SERVICE BULLETIN

#0020 Revision 2

SUBJECT: Eyebolt inspection and conditional replacement

MODELS AFFECTED: All Sling aircraft manufactured before the effective date (07/09/2022)

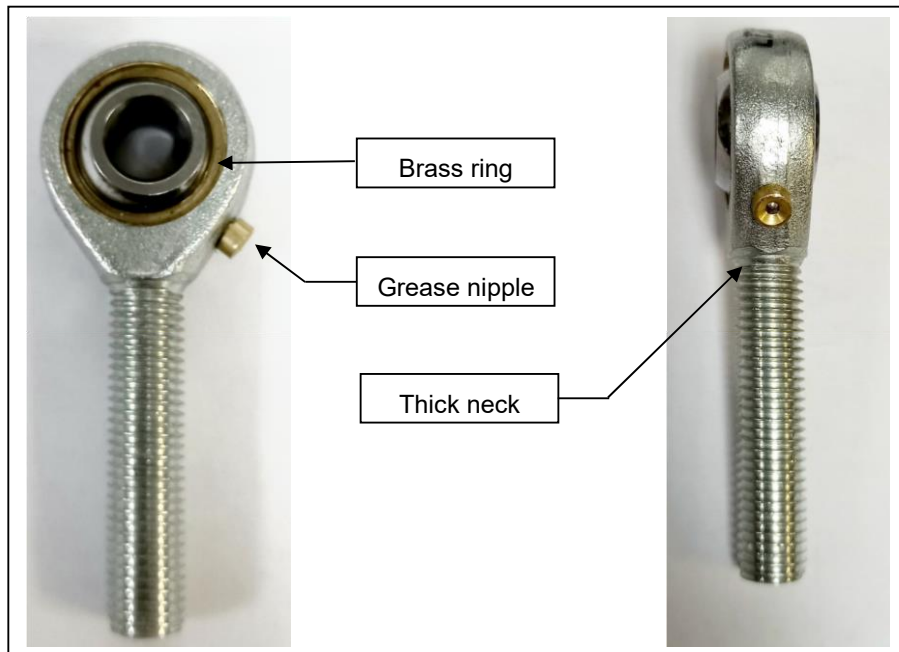
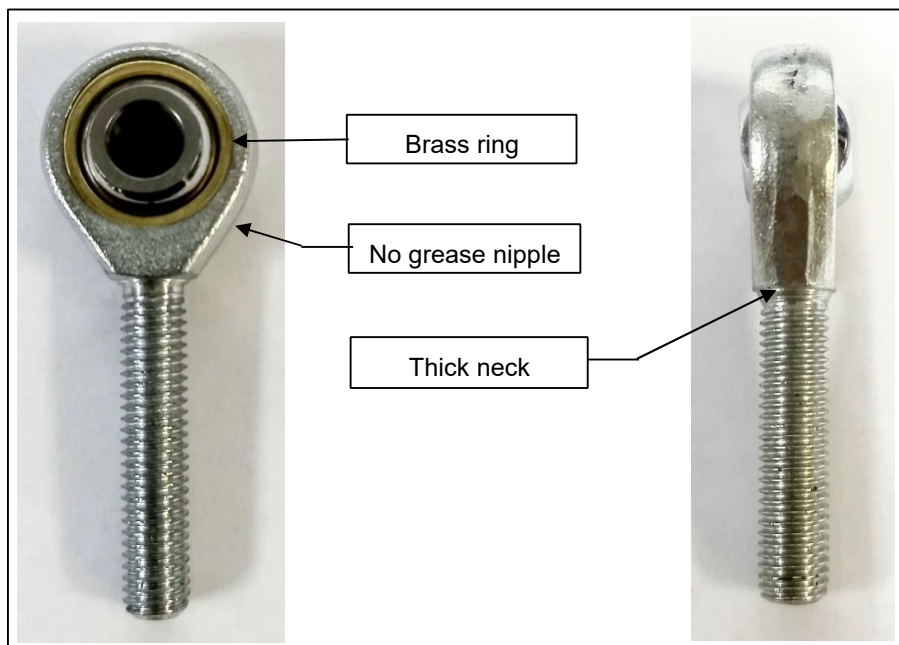
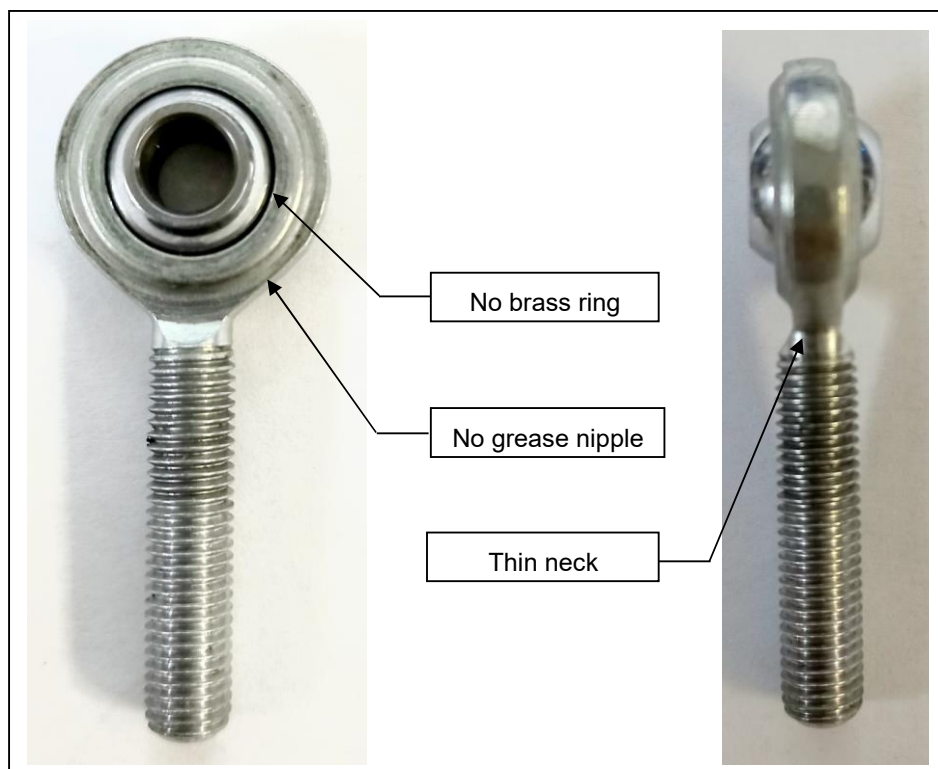
As seen below, the main difference between *type 3 and 4*, and the other two eyebolt types is the brass ring and shape of the neck of the eyebolt.

All eyebolts must be inspected at the aircraft's next MPI or annual inspection. This is applicable to aircraft that are already flying. Any aircraft still under construction must be inspected prior to its first flight. The various eyebolt types can be seen in Figure 1, Figure 2, Figure 3 and Figure 4 respectively. If *type 3 or 4* eyebolts have been supplied, they must be replaced.

Figure 5: Rudder and Nose Wheel Controls

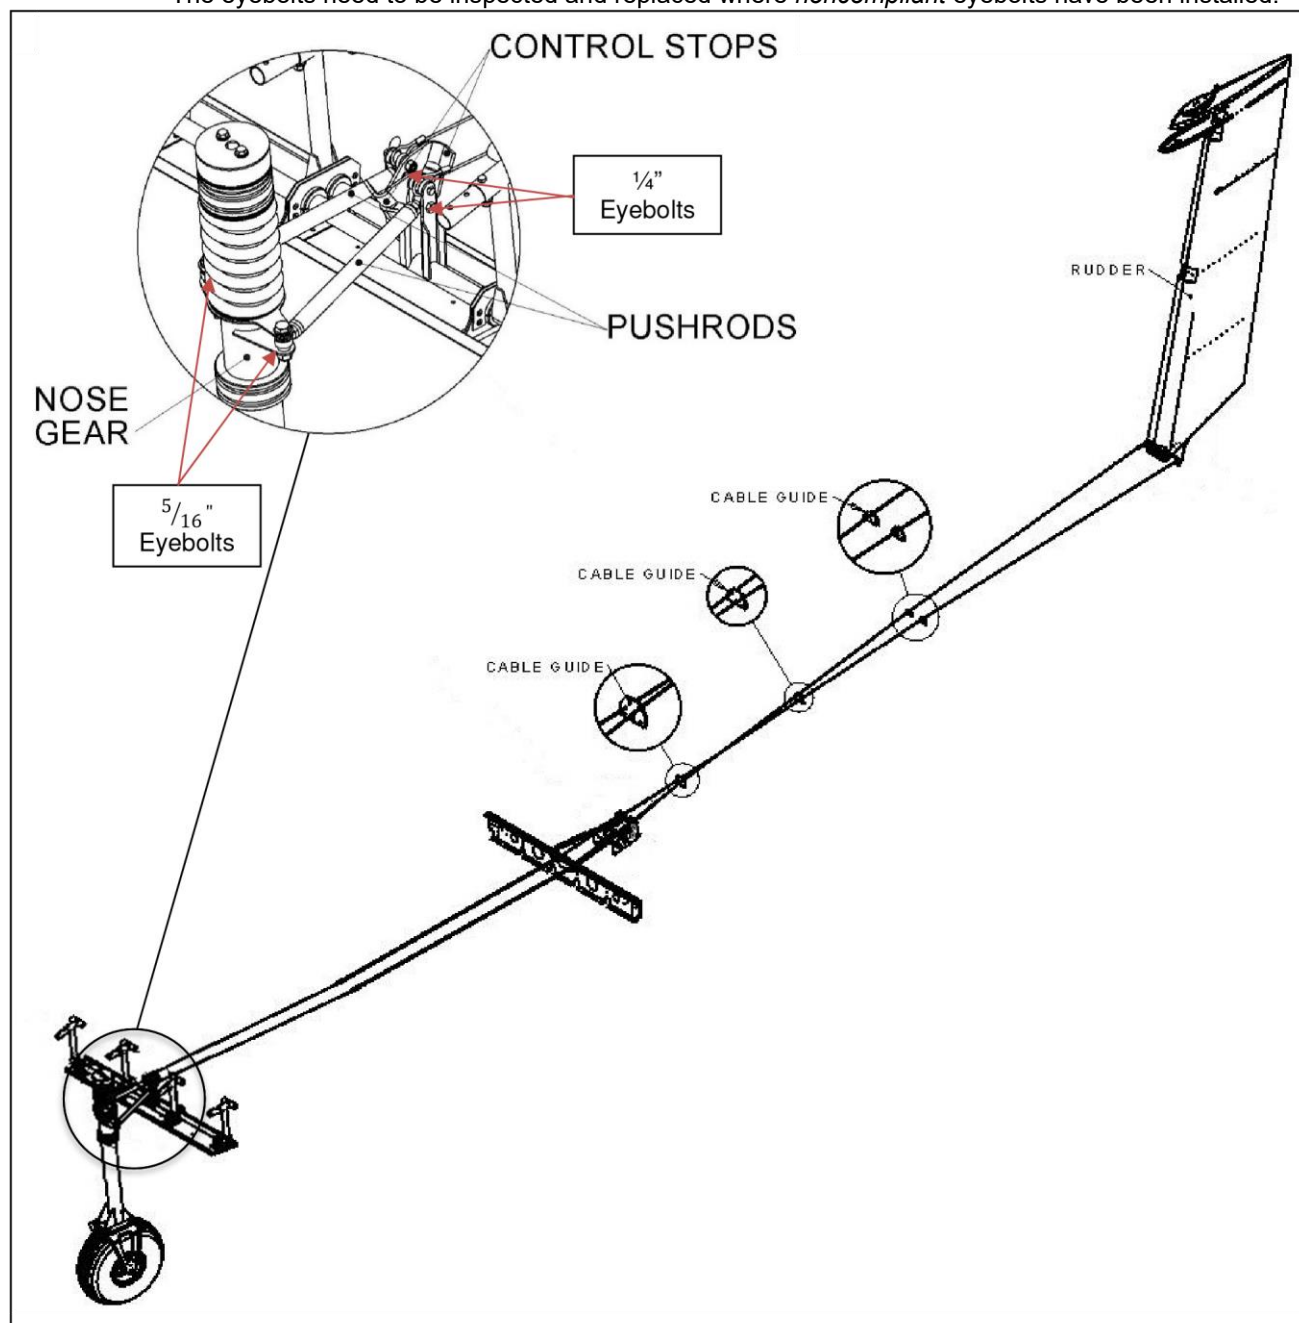
The eyebolts used in the rudder and nose wheel control arm assembly can be seen in Figure 5. The eyebolts need to be inspected and replaced where *noncompliant* eyebolts have been installed.

Step 4. Install new 5/16" eyebolts, either a *type 1* or *type 2* eyebolt, on the pushrods. To do this, reverse the procedure performed in Step 1.

Step 6. Replace the 1/4" eyebolts with the correct type (either *type 1* or *type 2* may be used), reinstall them onto the pushrod and connect them to the rudder pedal assembly once more. Refer to Figure 6 for the way in which the components fit together.

Figure 6: 1/4" eyebolt rudder pedal assembly

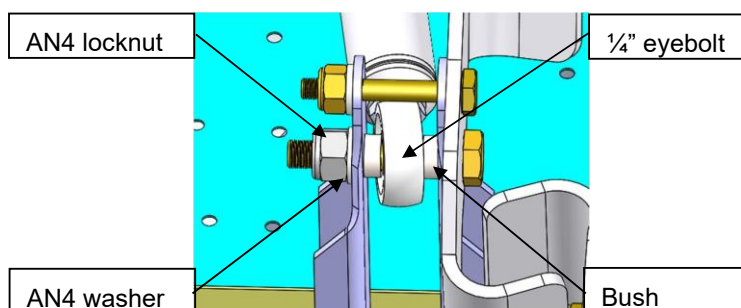
Step 5. Remove the 1/4" eyebolts, these are located on the rudder pedal assembly as shown in Figure 5, and can be accessed from inside the cabin. By referring to Figure 6, remove the AN4 locknut and AN4 bolt. The 1/4" eyebolt can now be uninstalled from the pushrod.

Figure 7: Aileron Controls

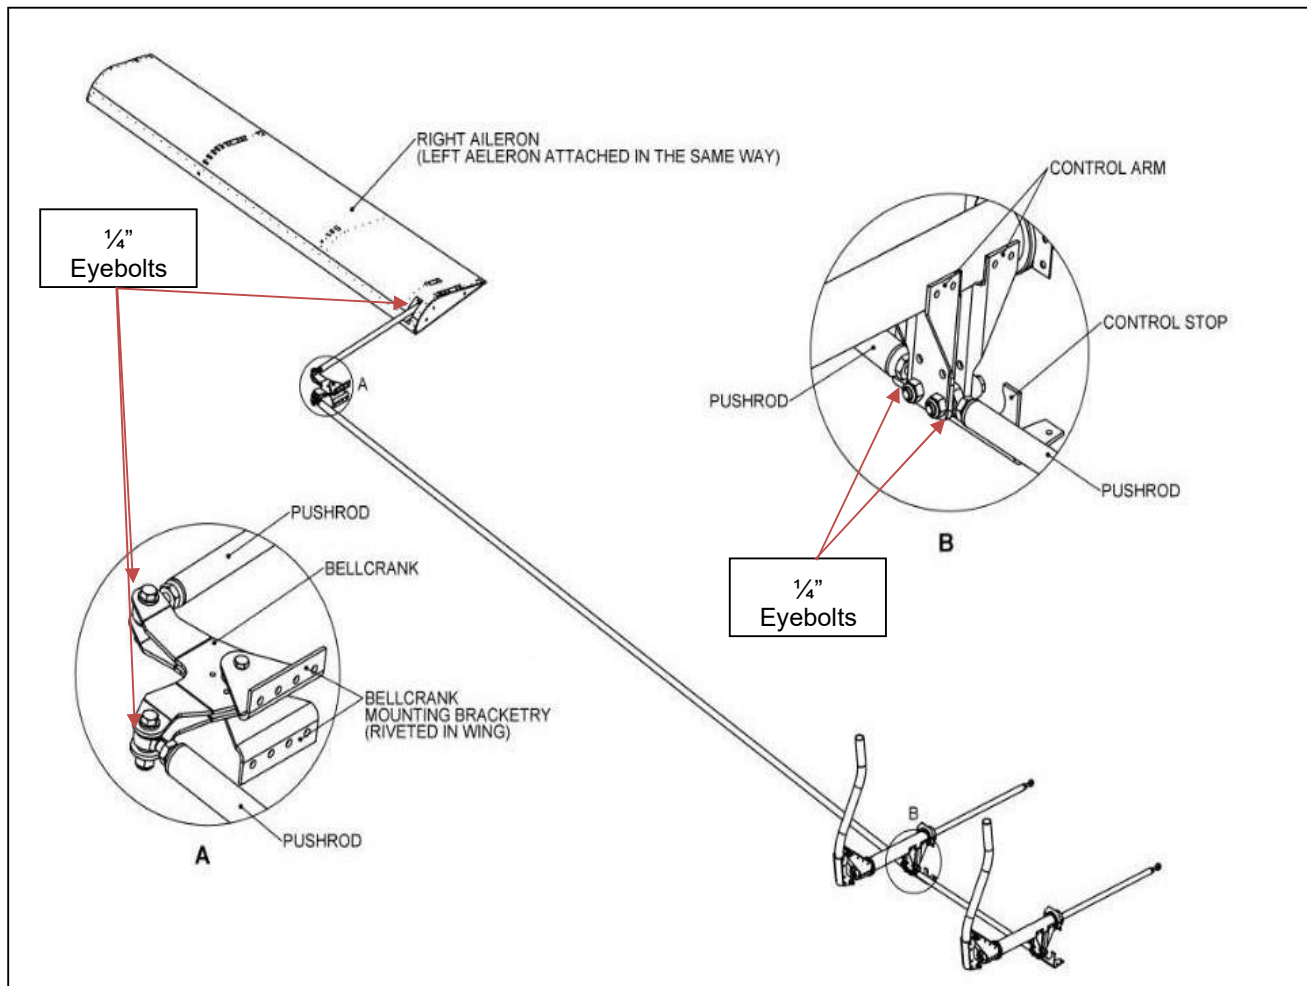
The eyebolts used in the aileron control assembly can be seen in Figure 7. These can be inspected using the inspection hatches located on the wing. Due to symmetry only one aileron has been shown. The same eyebolts will be found on the other side of the aircraft. The eyebolts need to be inspected and replaced where *noncompliant* eyebolts have been installed.

- Step 2. Ensure both eyebolts that are connected to the control arm in Detail B are replaced, with either a *type 1* or *type 2* eyebolt, if *noncompliant* eyebolts have been used.
- Step 3. Reverse the procedure in Step 1 to reinstall the eyebolt assembly.
- Step 4. To replace the eyebolts seen in Detail C of Figure 8, remove the AN4 locknut (13) and bolt (16). The eyebolt should now be uninstalled from the pushrod (5). A *type 1* or *type 2* eyebolt should then be installed on the pushrod.

Figure 9: Aileron bell-crank assembly

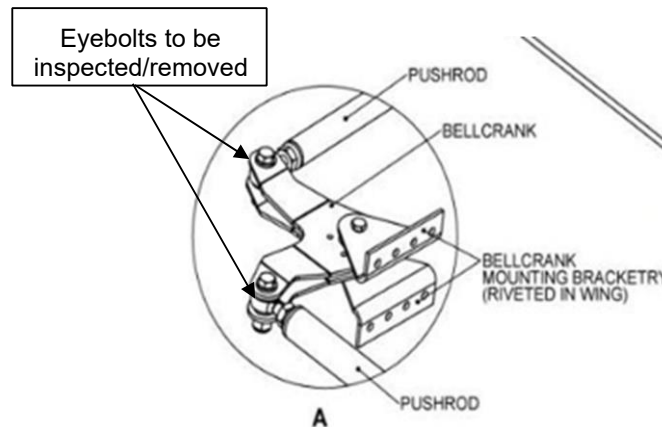
- Step 9. Refer to Figure 9 and remove the AN4 locknuts and bolts.
- Step 10. The eyebolts can now be removed and replaced with either *type 1* or *type 2* eyebolts, if required.
- Step 11. Reinstall the eyebolts to the bell-crank assembly, by reversing the procedure in Step 9 . Refer to the installation procedure in the manual shown in the table below for component placement:

Figure 10: Aileron leading edge eyebolt assembly

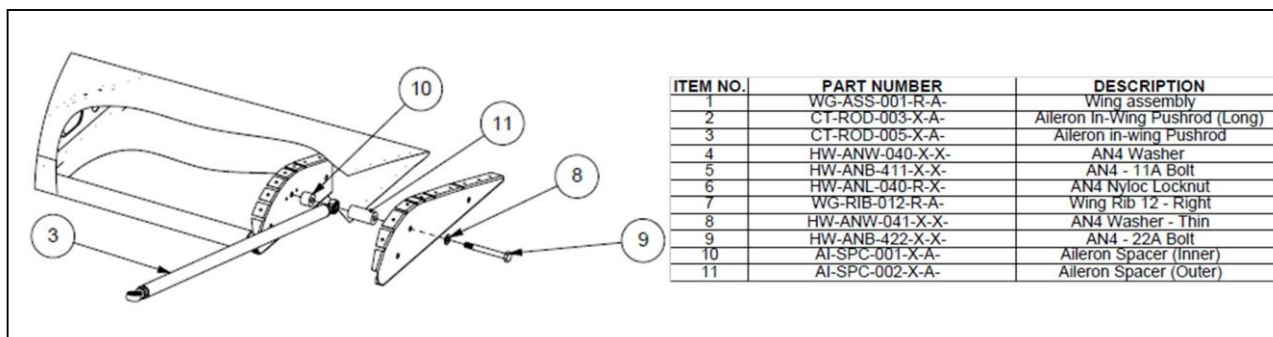
- Step 13. For the eyebolts located at the ailerons leading edge, remove the AN4 bolt (9) shown in Figure 10. To access this bolt, you will need to drop the flap. To do this follow steps 1 and 2 *only*, of the flap removal procedure (Option1). This procedure can be found in the applicable MAM shown in the table below. Remember to support the flap during this step as it may drop.

- Step 14. After bolt (9) has been removed, the eyebolt can be replaced with either a *type 1* or *type 2* eyebolt. Reconnect it to the aileron and pushrod (3), as shown in Figure 10. Support the aileron during this step as it may drop once the eyebolt has been removed.
- Step 15. Reattach the flap by reversing the procedure followed in Step 13.
- Step 16. Repeat Step 9 to Step 15 to remove the eyebolts used in the aileron control assembly on the other side of the aircraft.
- Step 17. You will need to adjust the ailerons once the new eyebolts have been installed, to ensure correct aileron deflection. To do this, follow the instructions in the applicable MAM shown in the table below:

Figure 11: Aileron Controls

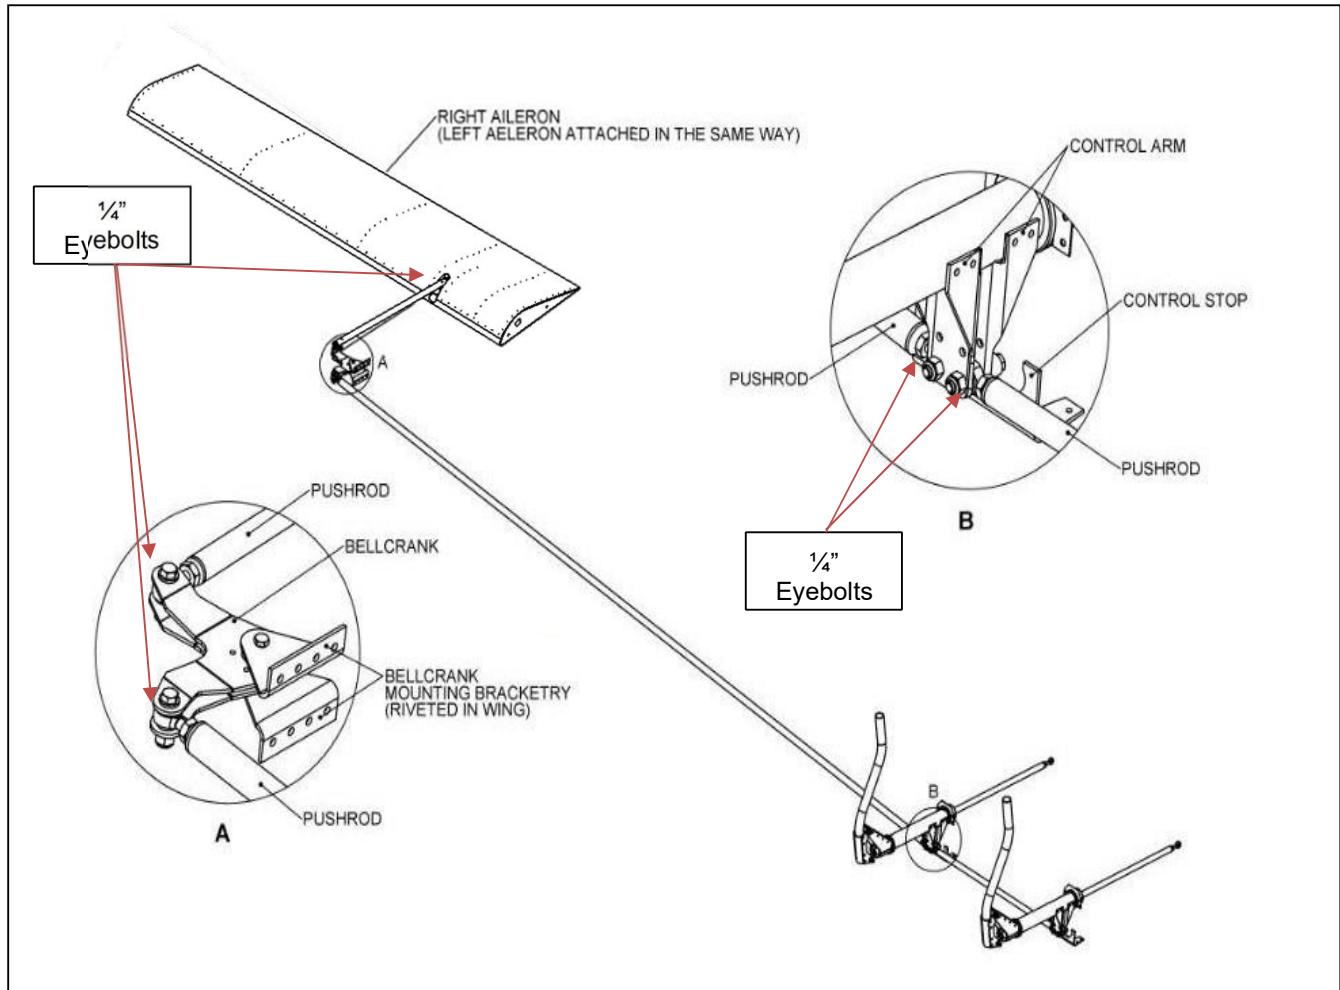
The eyebolts used in the aileron control assembly can be seen in Figure 11. These can be inspected using the inspection hatches located on the wing. Due to symmetry only one aileron has been shown. The same eyebolts will be found on the other side of the aircraft. The eyebolts need to be inspected and replaced where *noncompliant* eyebolts have been installed.

- Step 2. A *type 1* or *type 2* eyebolt should then be installed in place of the *noncompliant* eyebolt, if required. Ensure both eyebolts that are connected to the control arm in Detail B are replaced, if *noncompliant* eyebolts have been used.
- Step 3. Reverse the procedure in Step 1 to reinstall the eyebolt assembly. Do not replace the seats and control covers that were removed in Step 1 until the required eyebolts shown in Section 3.2.6 have been inspected and replaced, if required.

Figure 12: Eyebolt assembly, Detail C

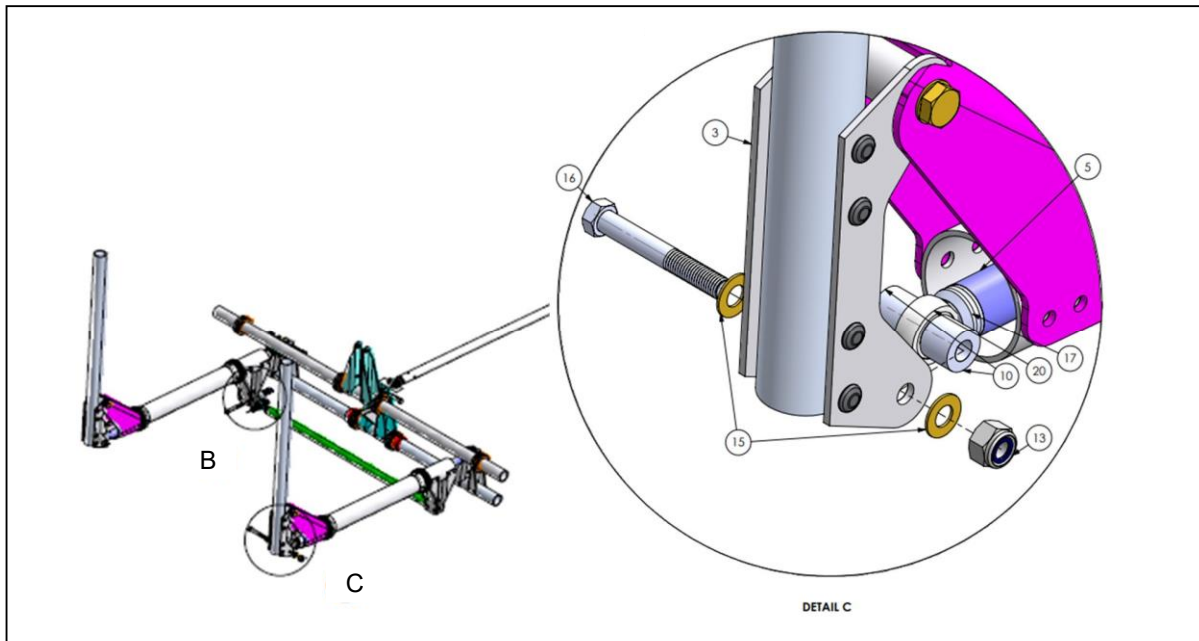
- Step 4. To replace the eyebolts seen in Detail C of Figure 12, remove the AN4 locknut (13) and bolt (16). The eyebolt should then be uninstalled from the pushrod (5). A *type 1* or *type 2* eyebolt should then be installed on the pushrod.

- Step 5. Reassemble the eyebolt assembly by reversing the procedure in Step 4, refer to Figure 12 for component placement.
- Step 6. The eyebolts used in the aileron bell-crank also need to be inspected and replaced if *noncompliant* eyebolts have been installed. These must be replaced with either *type 1* or *type 2* eyebolts. Remove the outboard inspection hatches on both wings, to expose the bell-cranks.

Figure 13: Aileron bell-crank assembly

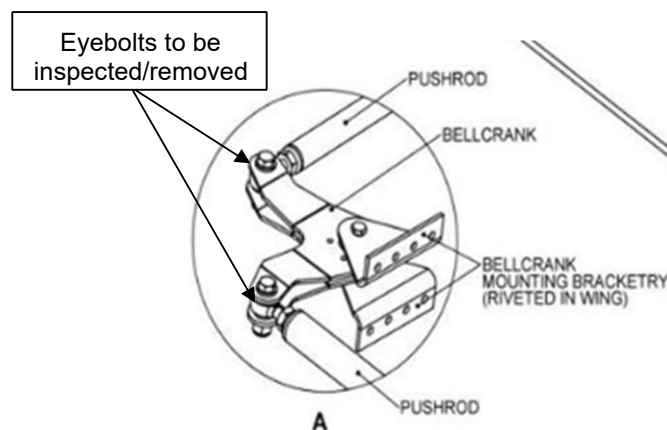
- Step 7. Refer to Figure 13 and remove the AN4 locknuts and bolts.
- Step 8. The eyebolts can now be removed and replaced with either *type 1* or *type 2* eyebolts, if required.
